DESIG	"LE	DRAWN BY	DART AEROSPACE USA FAIRCHILD INTERNATIONAL AIRPORT,	
CHEC	KED (APPROVED	DEO 9145	REV. A SHEET 1 OF 1
DATE			TITLE	SCALE
99.0	99.03.09		206/407 STEP LUG CHANGES	2:3
Α		99.03.09	NEW ISSUE (TSR A899)

DART ENGINEERING ORDER

TO AMEND PARTS D2731-1/-3/-5/-7 ON DRAWING D2731 REV. A

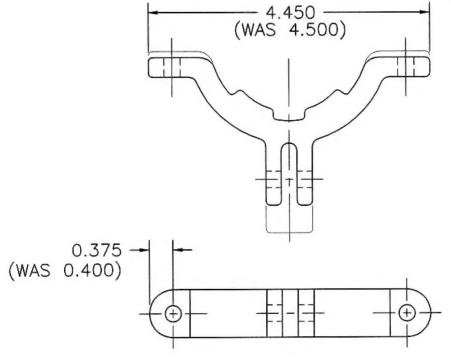
1) CHANGE THE FOLLOWING DIMENSIONS:

2) CHANGE FINISH FROM:
POWDER COAT WHITE (4.3.5.1) PER DART QSI 005 4.3

TO:

ACID ETCH AND ALODINE PER DART QSI 005 4.1 POWDER COAT WHITE (4.3.5.1) PER DART QSI 005 4.3
